STATE OF NORTH CAROLINA
DEPARTMENT OF TRANSPORTATION

Subject: **Request for Permit Modification** for TIP No. U-2404 A, Catawba
County, Newton/Conover Loop; State Project No. 8.1792401; Federal Aid
Project No. MA-STP-16(2), Division 12.

Reference: Individual Permit, USACE Action ID No. 200331233, issued on
December 4, 2003. Major Certification, DWQ Project No. 031048, issued
on October 8, 2003.

The U.S. Army Corps of Engineers (USACE) issued a Section 404 Individual Permit (IP) to the North Carolina Department of Transportation (NCDOT) on December 4, 2003 for construction of the Newton-Conover Eastern Loop, from NC Highway 16 north to SR 1739 (Emanuel Church Road) east of Newton, Catawba County. The purpose of this letter is to request a modification of Permit Site Nos. 1, 3, & 5.

SITE #5

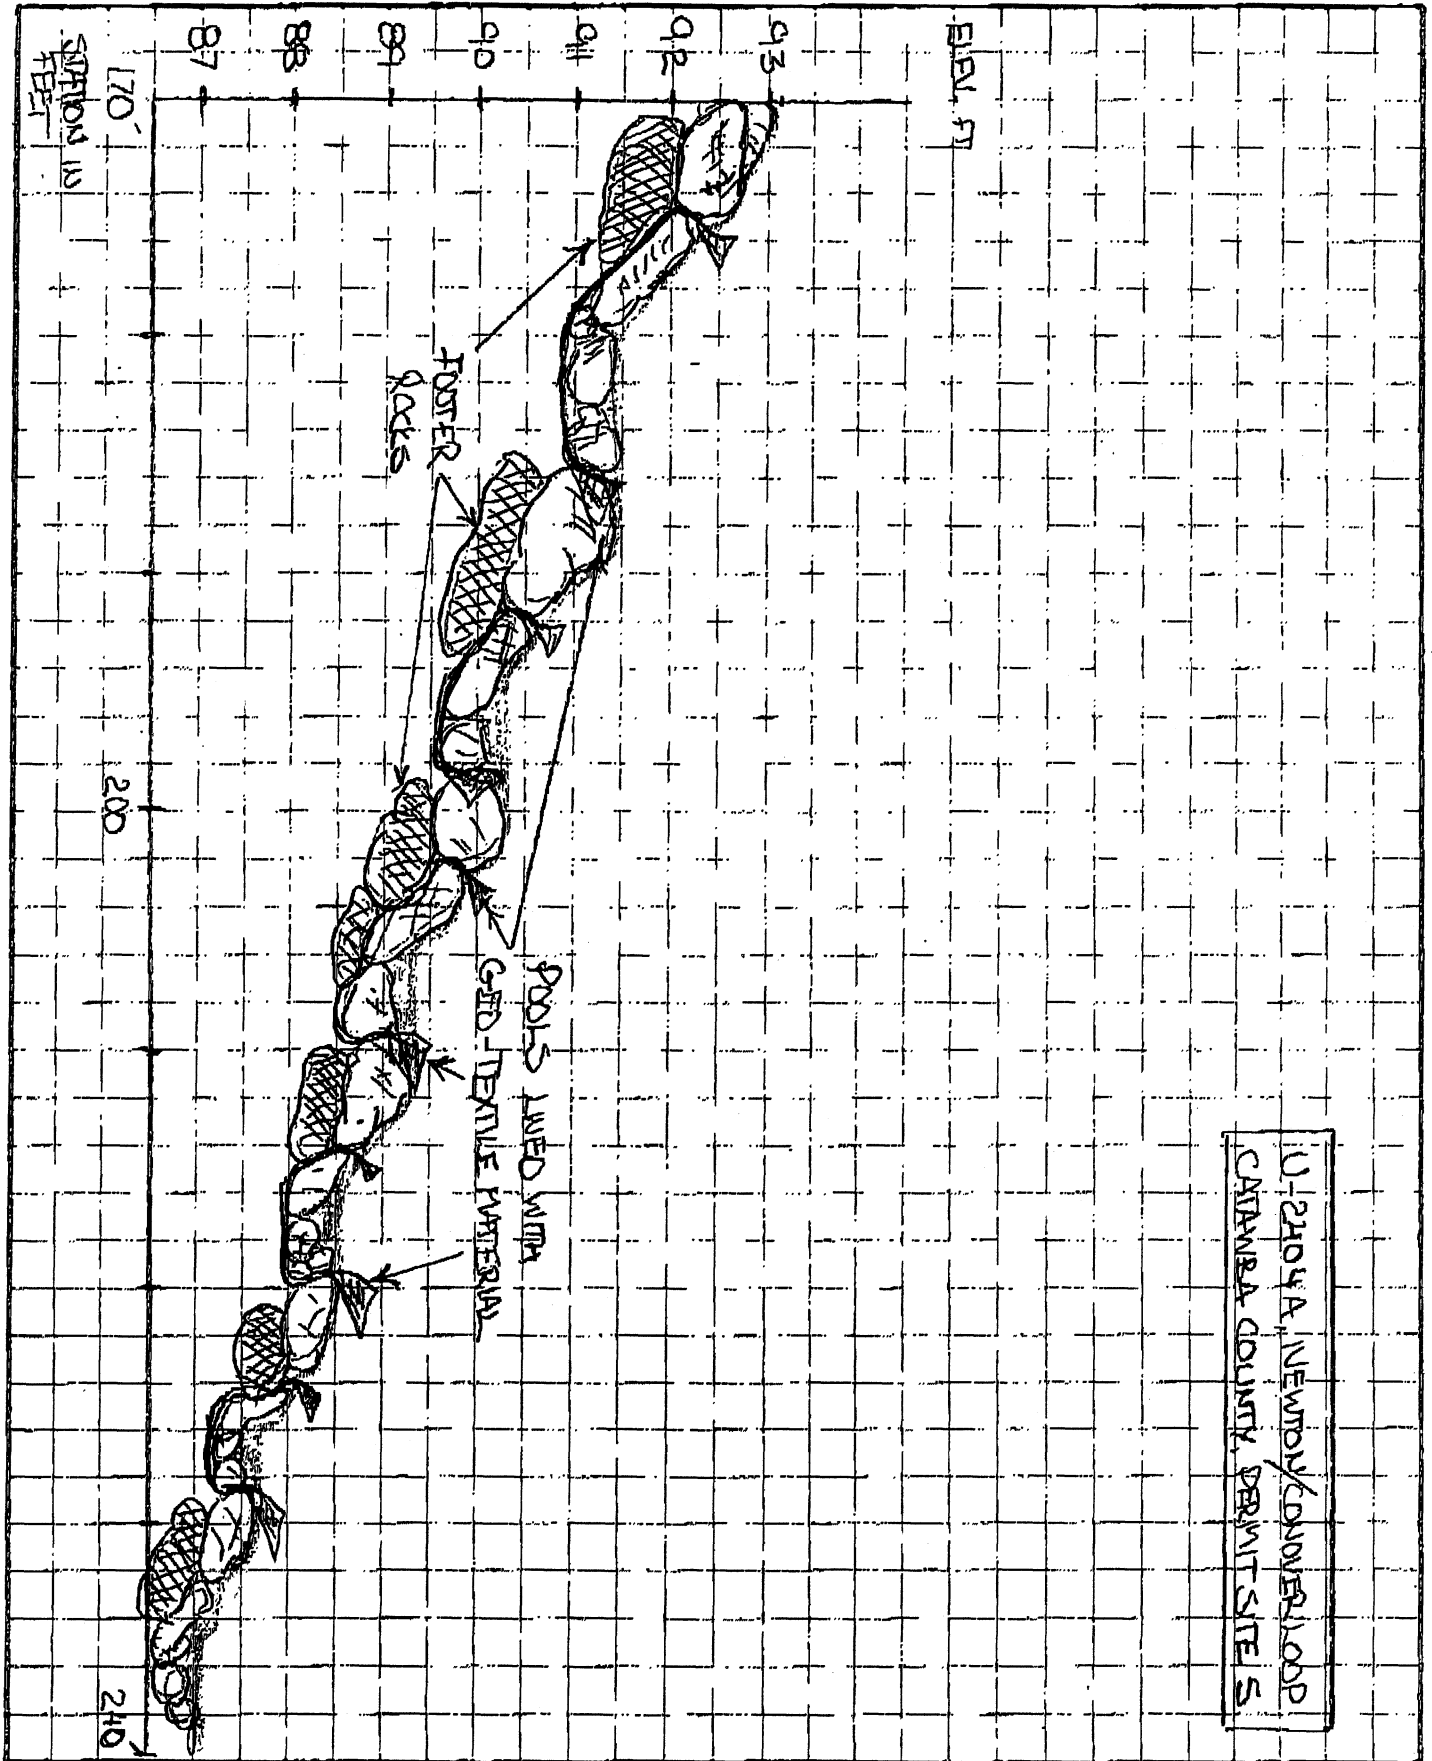
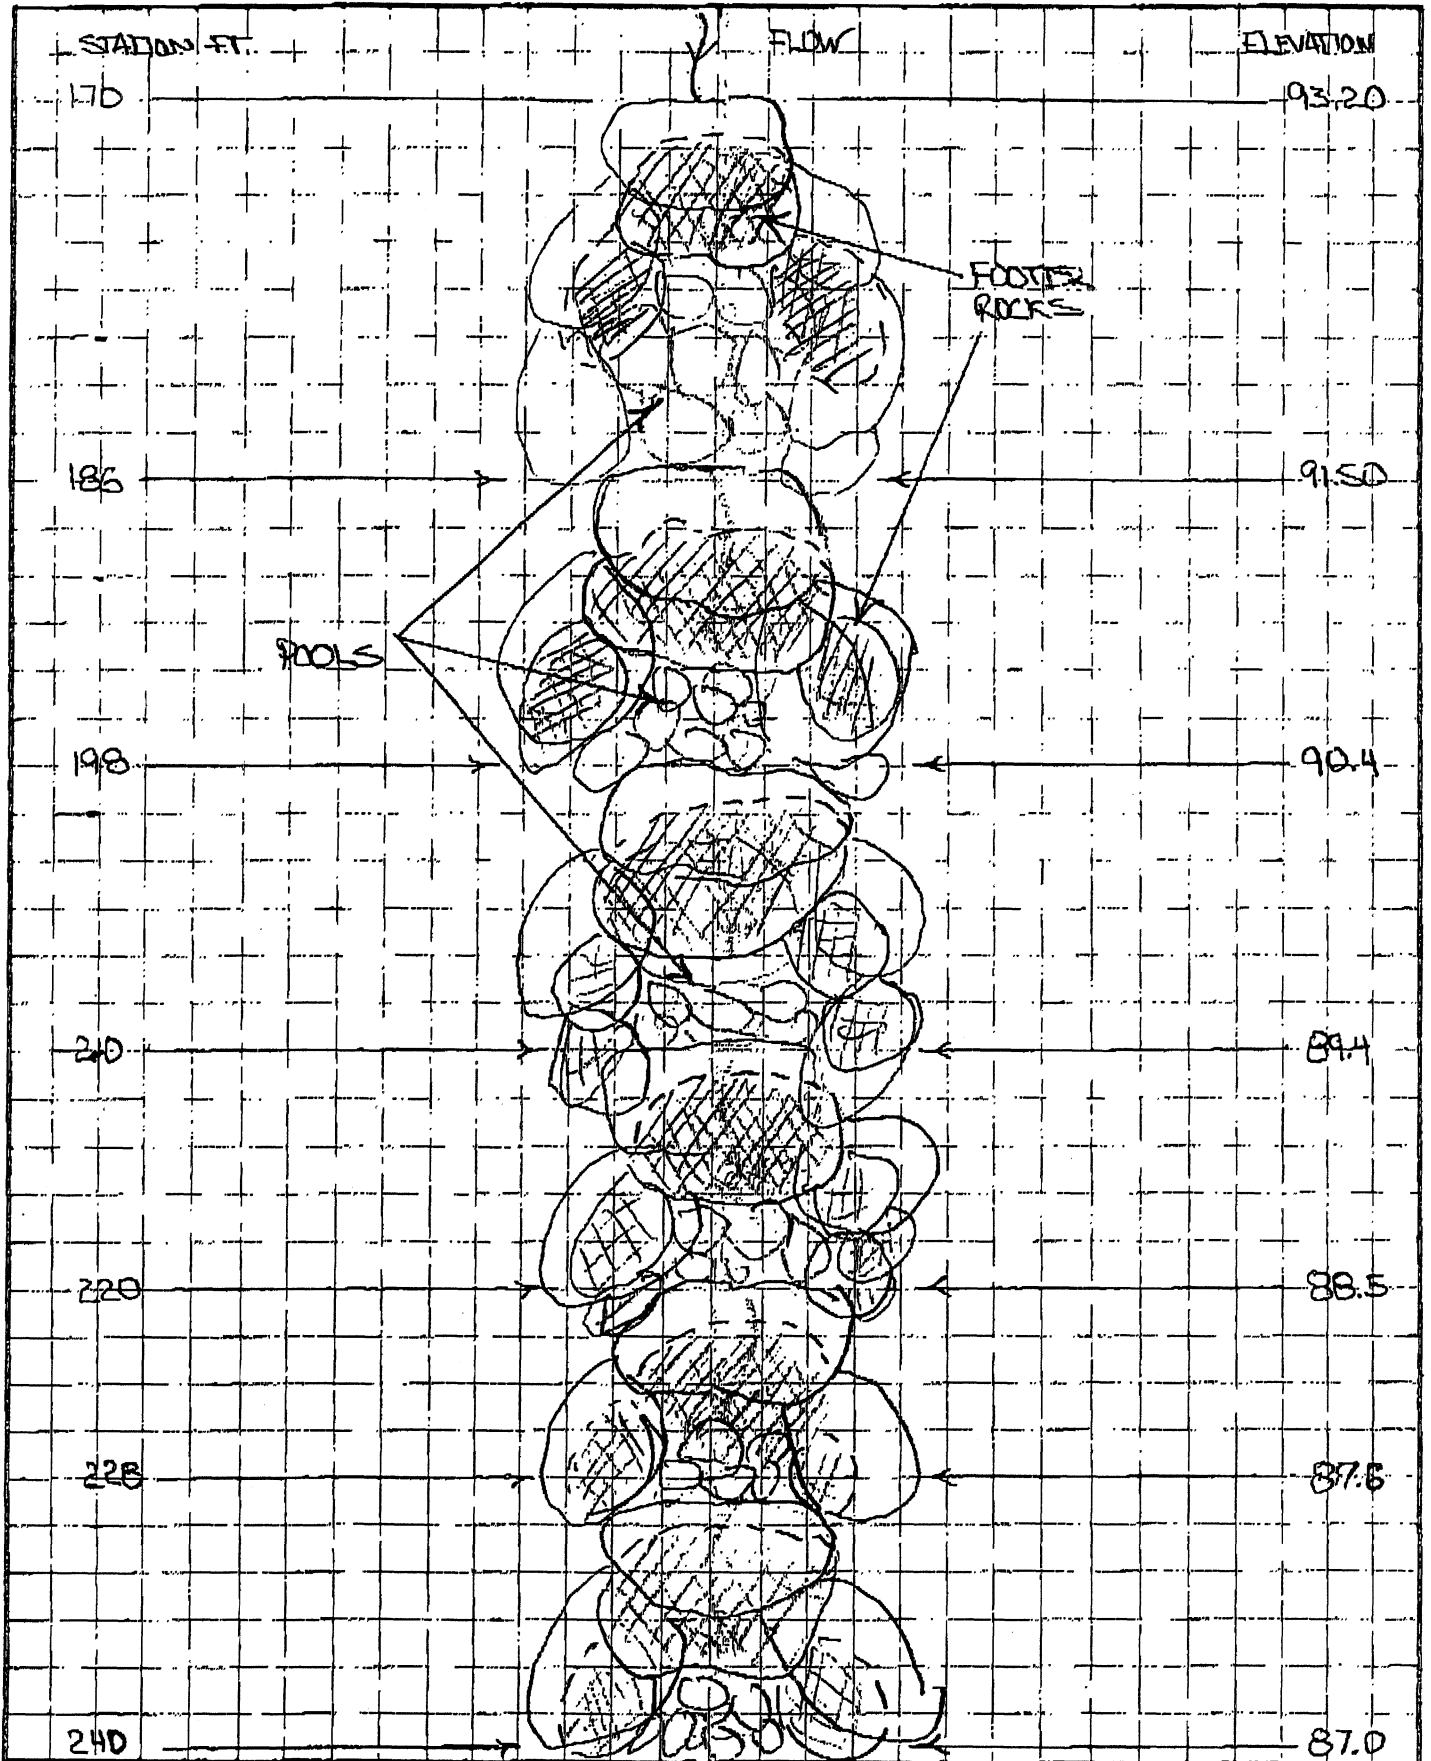
Permit Site No. 5 is located at the headwaters of an unnamed tributary to McLin Creek. The area originally consisted of two ponds in a series which were fed by springs, seeps, and storm water runoff. During construction of the subject road project, one pond was filled and the second pond is currently being used as a sediment basin. Plans indicate (see attached construction plan sheet number 13) that after construction the remaining pond is to be "graded to drain," however, the original streambed below the existing pond is incised with eroding stream banks. It is anticipated that upon project completion, and removal of the existing pond, that the stream will head cut due to soil type and additional storm flow from the road project. It is therefore proposed that rock cross vanes be

installed to act as grade control and coconut fiber matting be used to stabilize the stream banks.

The stream length, from end of pipe to edge of temporary drainage easement is 240 feet. The change in elevation is 7.8 feet, which puts the stream slope at 3.2%. It is proposed that the cross vanes be constructed in accordance with Rosgen's principles of stream morphology. There is natural rock of the appropriate size and quantity available on site for the construction of the vanes.

Permit
 Site #1
 Rock Cross Vanes
 on outlet of
 pipe

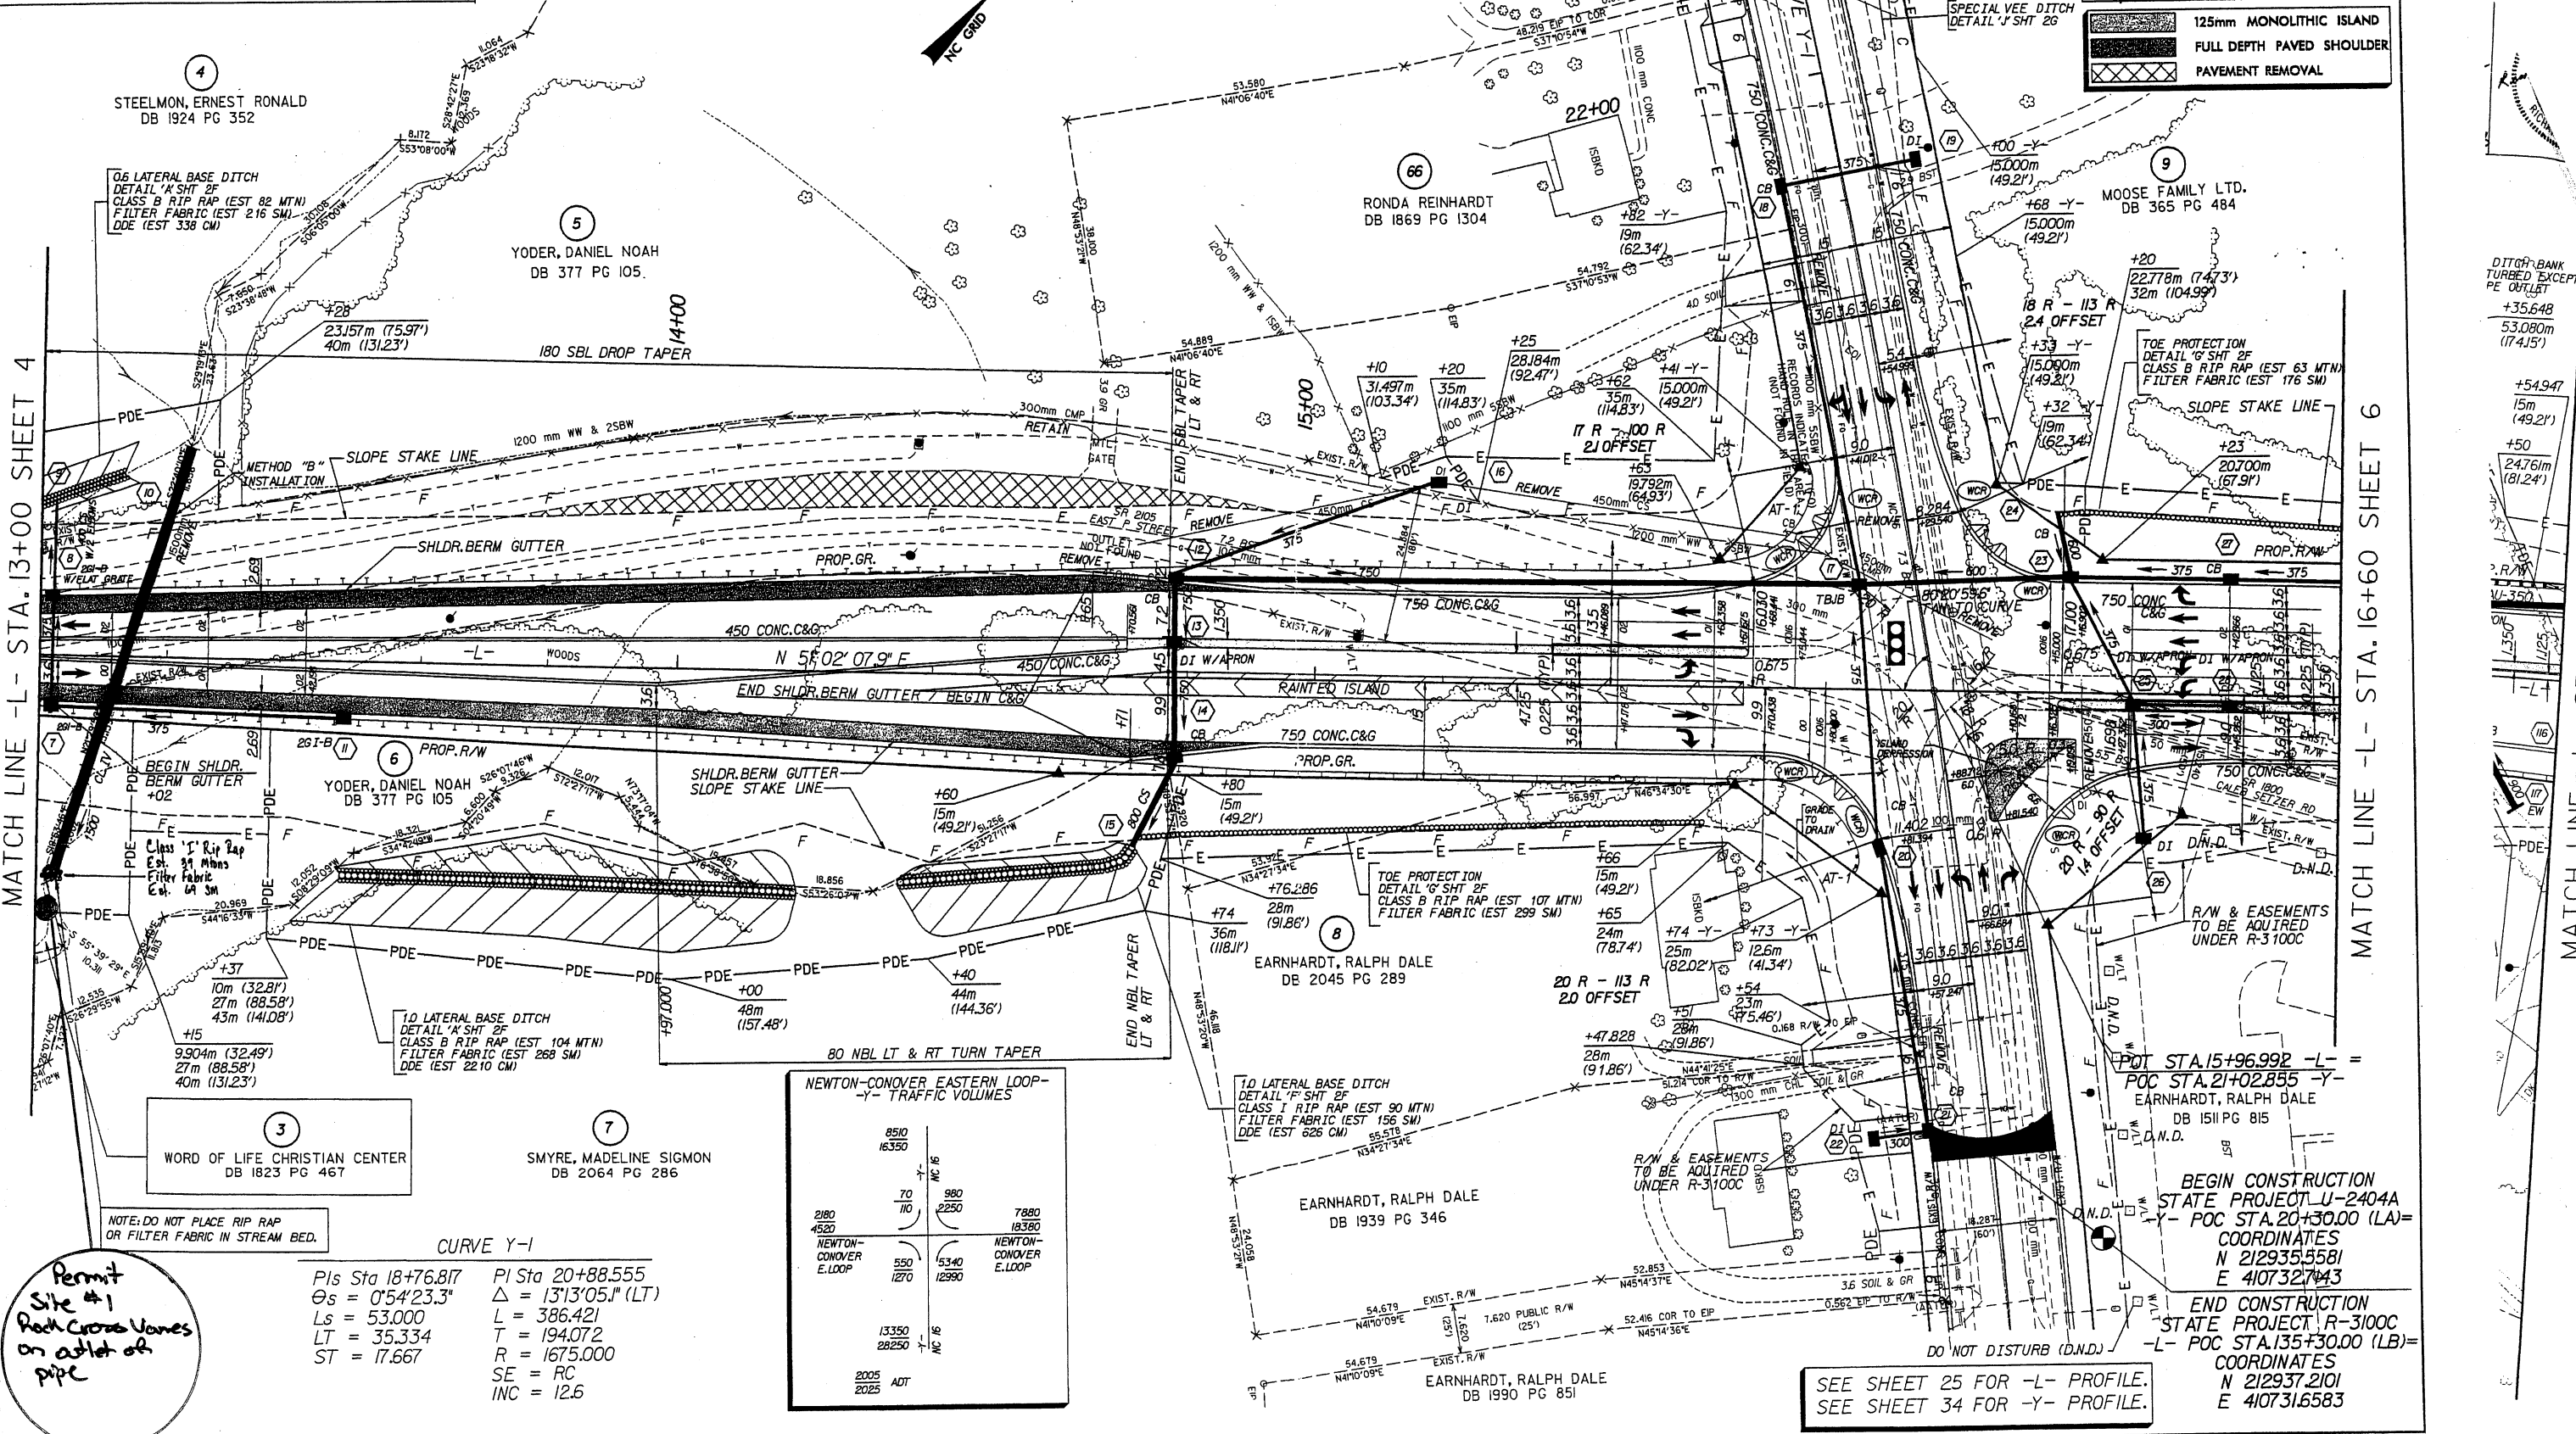
During a 401 Permit Compliance Inspection conducted by DWQ on December 13 & 17, 2004, it was requested that rock cross vanes be installed at Permit Site Nos. 1 & 3. The cross vanes are to be used for grade control to stop head cutting.

At Permit Site No. 1 it appears that rip-rap has fallen into the stream from the bank armoring the outlet end of the pipe. There is an approximate one foot grade change from the end of the pipe to a hard bend approximately 20 feet downstream which is creating the head-cut.
